Re: Planning Application 2016/0552P - (23 Gayton Cresecent, London NW3 1UB)

rodriguesassociates 1 Amwell Street London EC1R 1UL tel. 020 7837 1133 www.rodriguesassociates.com		SK 01	Rev.
Job Title	23 Gayton Crescent A/C proposals		
Calculations	Date	29 th April 2016

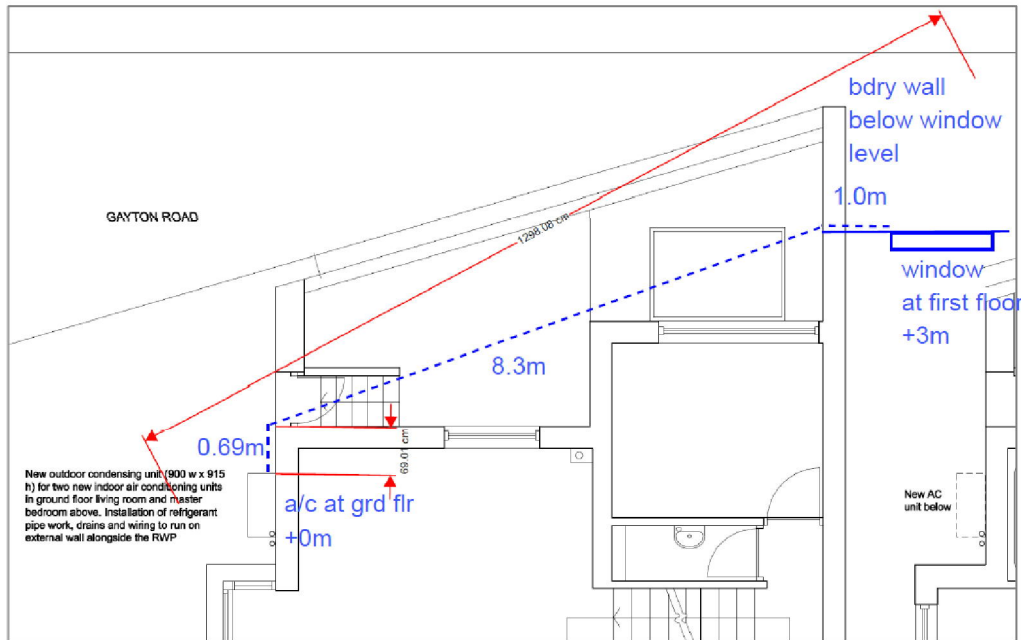
1. We now understand how the acoustic engineer got the distance to the nearest affected façade wrong. He has clearly not viewed the properties and has misunderstood the plan he has been working from. We attach a plan that has been prepared by a chartered structural engineer that shows the correct location of the façade. It is not at the end of the boundary wall, as assumed by the acoustic engineer. As can be seen from the plan we attach the distance to the nearest noise-sensitive façade is under 11m. Moreover it is worth noting that the boundary wall does not rise the full 3m height of the ground floor but only 2m, so that the acoustic engineers assumption that the first floor is the nearest affected façade is a further miscalculation.

3. As explained, the plans were misinterpreted by the acoustic engineer. Measuring to one metre from the noise sensitive façade is, we imagine, likely to result in a distance even shorter than that given on the attached plan. However, not being experts in this field, we do not know where the one meter should be placed. Since, as points 1 and 2 show, we can have no confidence in the figures quoted by the acoustic engineer, we ask that the planning committee reviews this point.

The sketch below shows the derivation of the shortest direct distance between the proposed condensing unit location and the first floor window of 38a Gayton Road. Apart from the two corners shown, there is no intervening wall as the boundary wall is well below the level of the window.

Total horizontal distance a/c to window = 9.99m
 Vertical distance a/c to window = 3m
 Total distance by shortest direct line = 10.43m
